Per
^
Groundwater Application Review Summary Form

Application # G- 17998

PUBLIC INTEREST REVIEW FOR GROUNDWATER APPLICATIONS

TO: Water Rights Section Date 07/24/2017
 FROM: Groundwater Section Phillip I. Marcy
 Reviewer's Name
 SUBJECT: Application G- 17998 Supersedes review of 08/05/2015**
 Date of Review(s)

Well Location Map

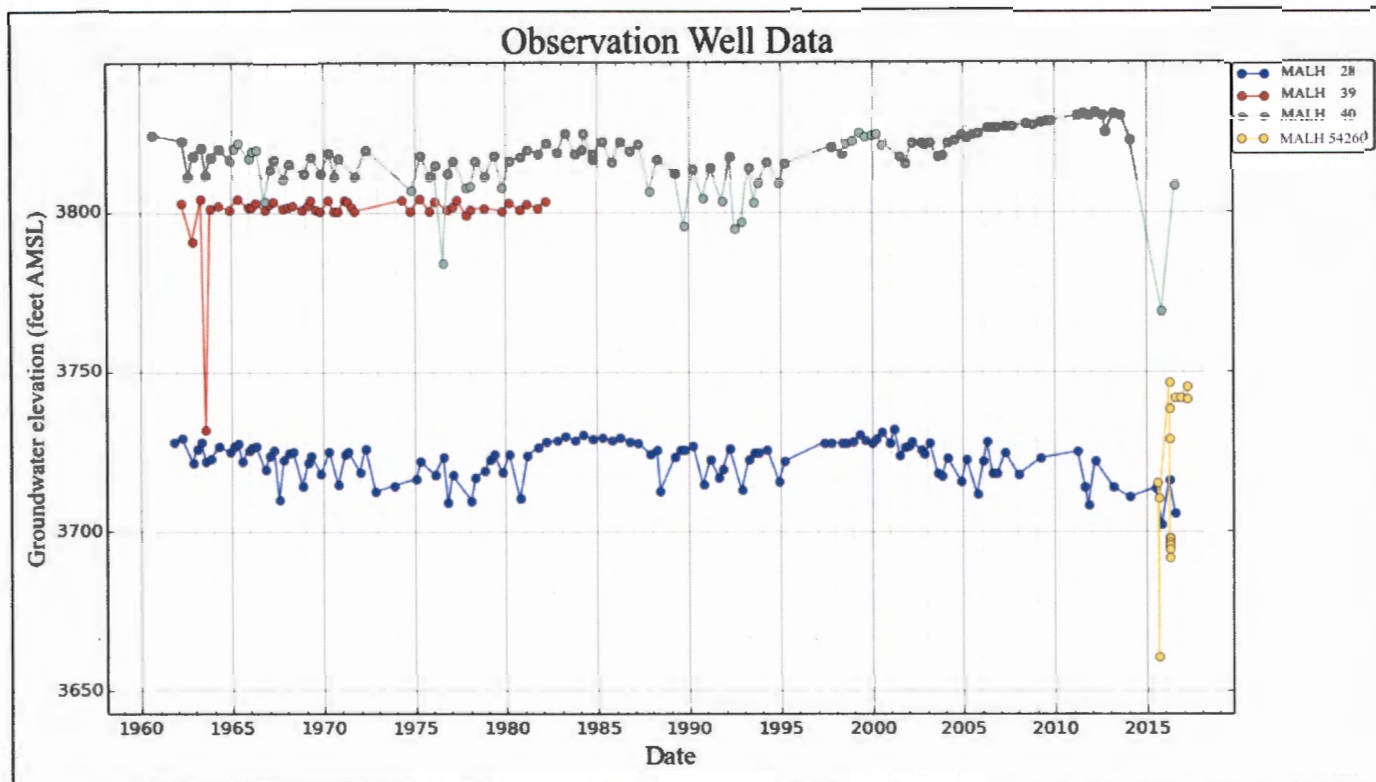
**** This re-review addresses the applicant's change of location of the proposed POA well, submitted 06/20/2016.**

Comments: The updated POA location (received map 06/20/2016) is greater than one mile from nearby perennial surface waters, therefore the above table does not apply.
